Re: Project Management and Design Consultant Services for Sherwood Recreation Center (Phase 4)

Contract Change Order #1

Re: City of Salinas; Add Service 1, CAD backgrounds
MEI Project # 821

Re: City of Salinas; Add Service 2, Misc scope changes at CNC and Sherwood Center
MEI Project # 821

Phase 1 Sherwood Center roof framing plan; the only dimensioned plan available

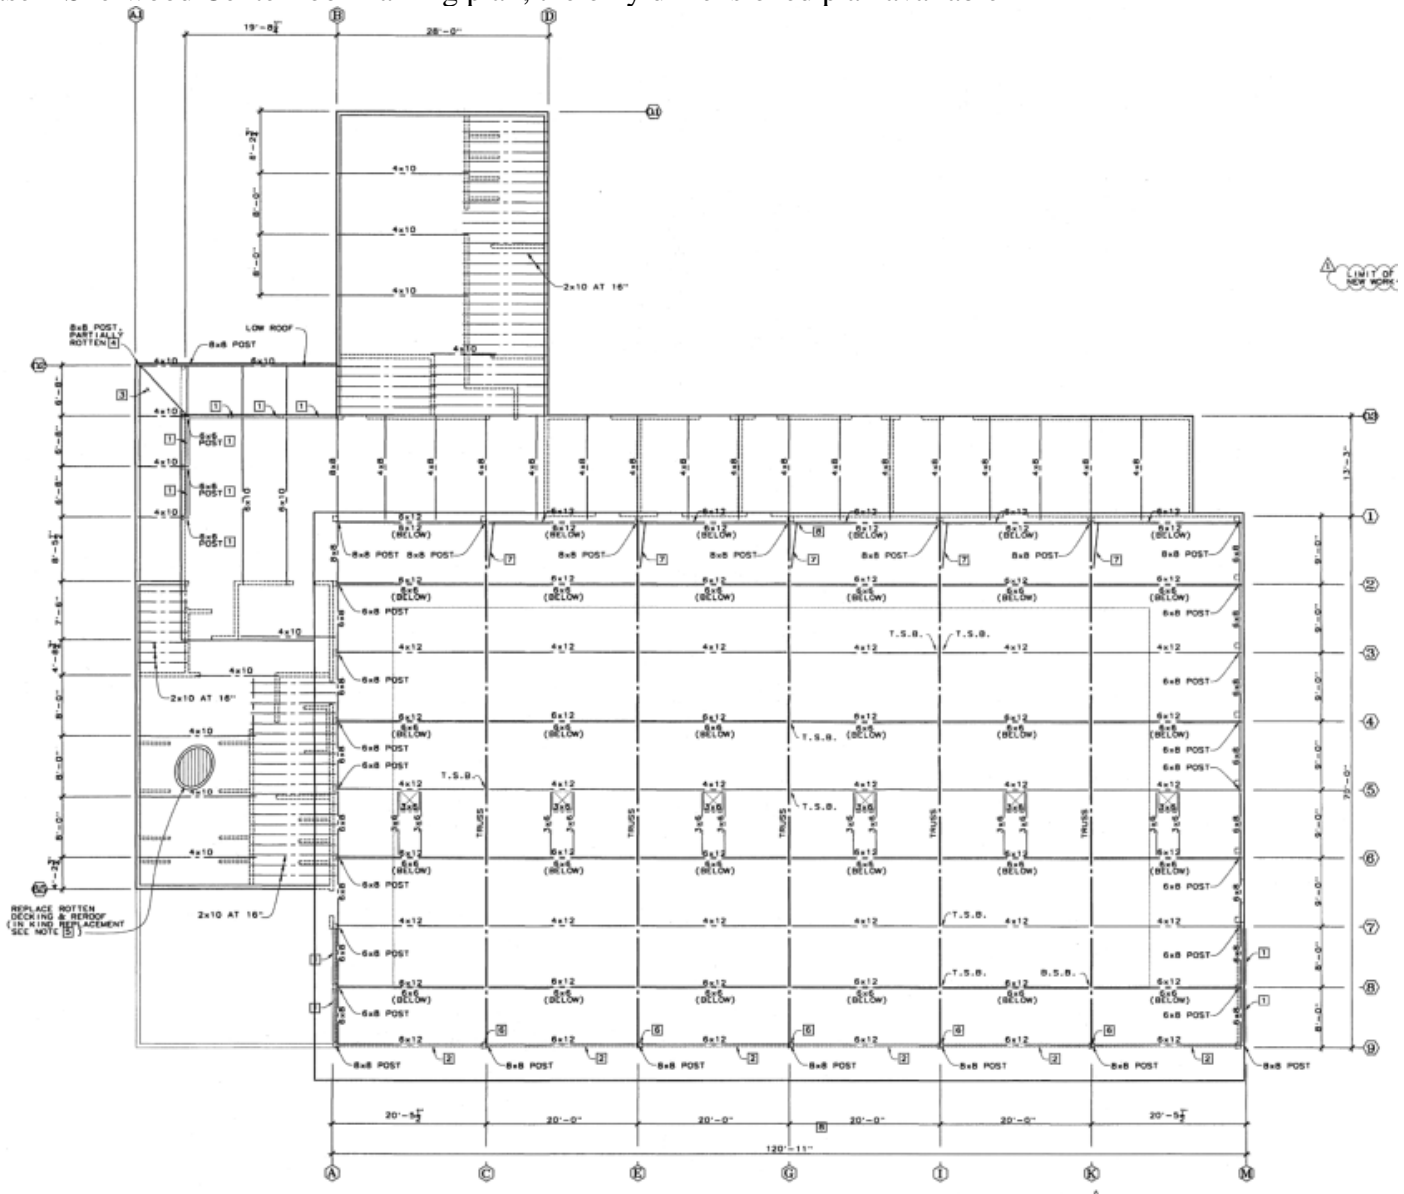
Sherwood Recreation Center: As noted previously, there appears to have been at least 3 phases of work done at the Sherwood Center and we have only been provided with Phase 1 and Phase 3 drawings. These drawings, while prepared on CAD, are much more limited in information than the Chinatown Navigation Center drawings. Phase 1 was the original demolition of the pool and infill. Phase 3 was the more recent interior renovation work which gives us our current plan. While the basic room layouts are present, we will need to come down to the site to take measurements and photos so we can accurately locate these elements and create exterior elevations that are accurate enough to prepare our work from. We will need to do this in 3 phases; initial creation of CAD plans so we can prepare plots to bring down for our site visit, followed by final drafting of plans.

We will prepare the projects in Revit and the database will be turned over to the City after completion of the project. While this work will allow us to proceed with the design work, there may be some critical information in the missing Phase 2 Sherwood drawings that will shed some light on the construction of the infill wall on the south side of the gymnasium space. We can only guess as to what foundation exists under the infill walls and we were informed that there was a potential water intrusion issue at the base of that wall, so we can only design to the information that we have been given or to what is observable to the eye.

Phase 1 Sherwood Center roof framing plan; the only dimensioned plan available

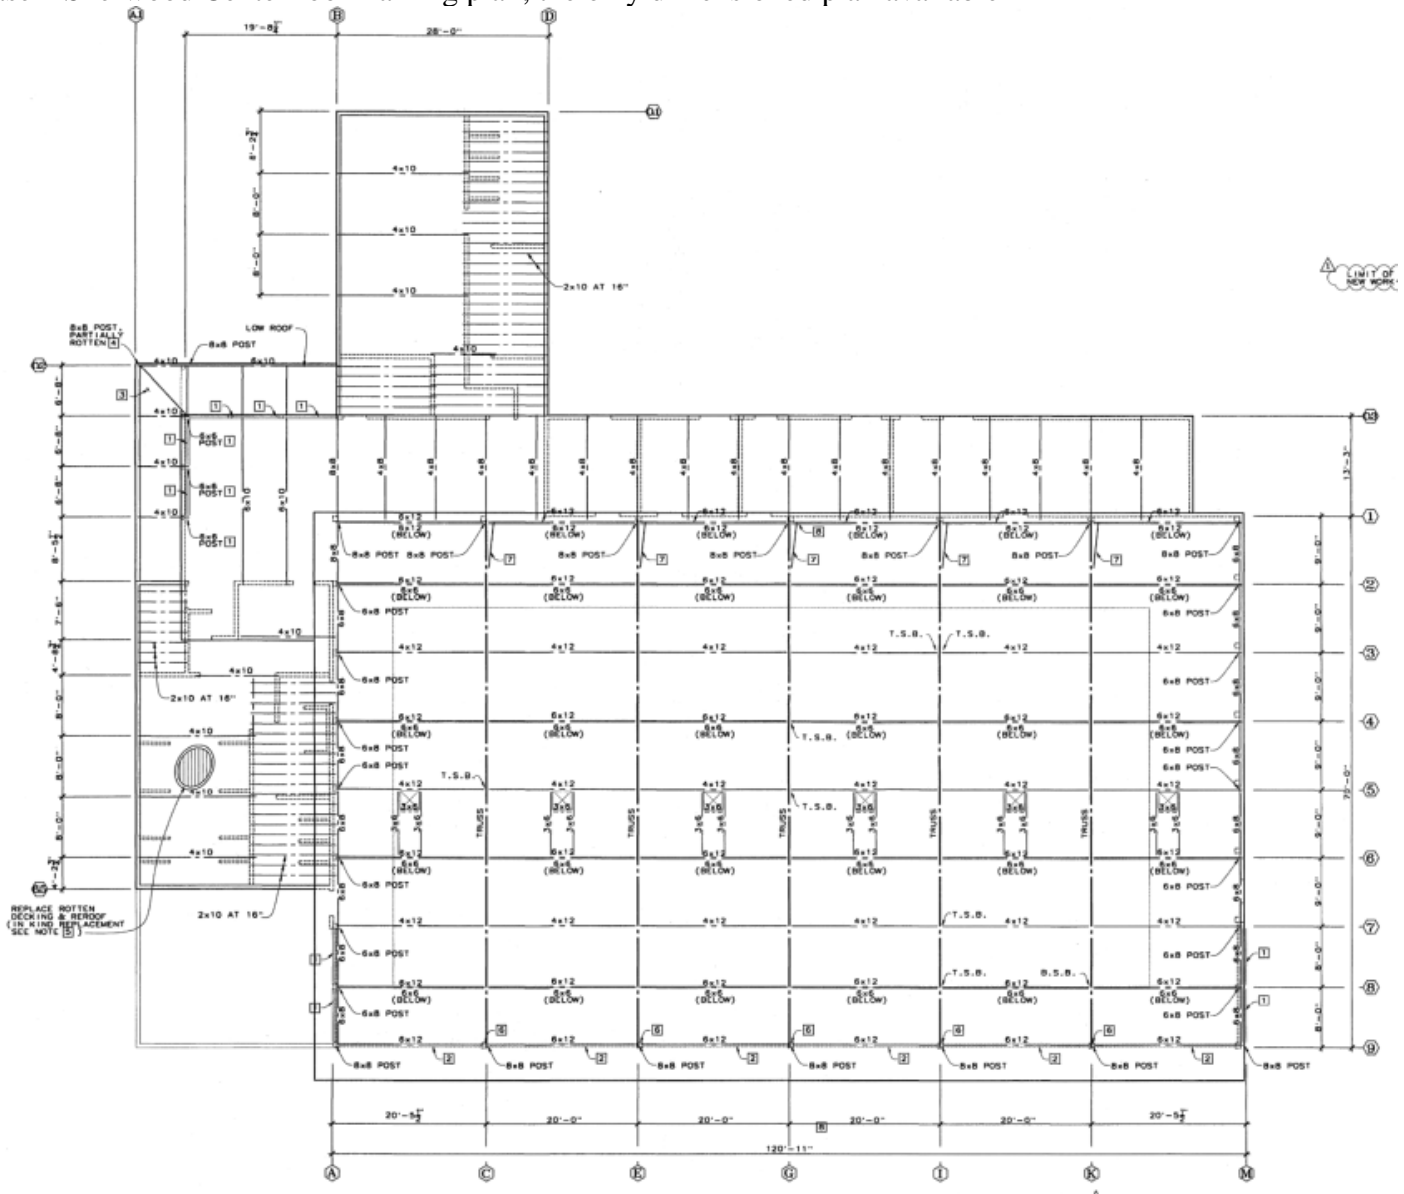
1. During our previous site walks, we discussed and confirmed the removal of the abandoned stair and associated roof structure at the NE corner of the center. There is no added cost for this work.

2. During our 8/16/23 site visit, the City asked us to remove the existing CMU screen walls on the west side of the building in front of the multipurpose room on the west side and the Women's restroom and shower on the north side of the building. As part of this work, we agreed to add a parapet to the top of the women's restroom wing to match the existing CMU wall that will remain. We are requesting \$3,300 for RPM to perform structural analysis for this work, including the new parapet design, and 8 hours of principal time and 24 hours of draftsman time for the additional design work in these areas.

3. During our 8/16/23 site visit, we discussed removing the existing access door to the storage room on the west side of the facility and to replace the existing concrete paving on the south side of the facility with new concrete paving and trench drains. The original scope of work did not include repaving this area. We are requesting \$4,500 for RPM to perform civil work related to drainage and paving of this area and 3 hours of principal time and 12 hours of draftsman time for MEI to coordinate and incorporate these design changes.

4. During our 8/16/23 site visit, we took photos of the existing roof and rooftop equipment. It appears that the roof is in basically good shape and the water intrusion that we noted earlier was from improperly sealed skylights. We are not including any reroofing scope for the Sherwood Center in our project, but can advise the GC as to removing the existing skylights/curbs and reroofing this area at no additional cost.

5. Subsequent to our 8/16/23 site visit, there have been emails from the City discussing the possibility and desire to remove the existing painted wood shingles from the building and replacing them with another material. There was also the mention of the likelihood of Lead Based Paints being present on the wood, given the age of the facility. The City circulated previous surveys and removal specifications which we have responded to separately in an email to CSG and the City representatives. *Hazardous material removal is not included in our work scope* and we recommend that CSG or the City contract separately for this scope of work; we are happy to provide access to our drawings/documents to any remediation professional. Regarding replacement of the existing wood shingles (which are in very poor shape and need replacement anyway) with a different material, the City has mentioned the need to go through NEPA/Environmental review for this project. We are including with this add service request, an allowance of 16 principal hours and 48 designer/draftsperson hours for design work with rendered elevations/perspectives for community/city review.
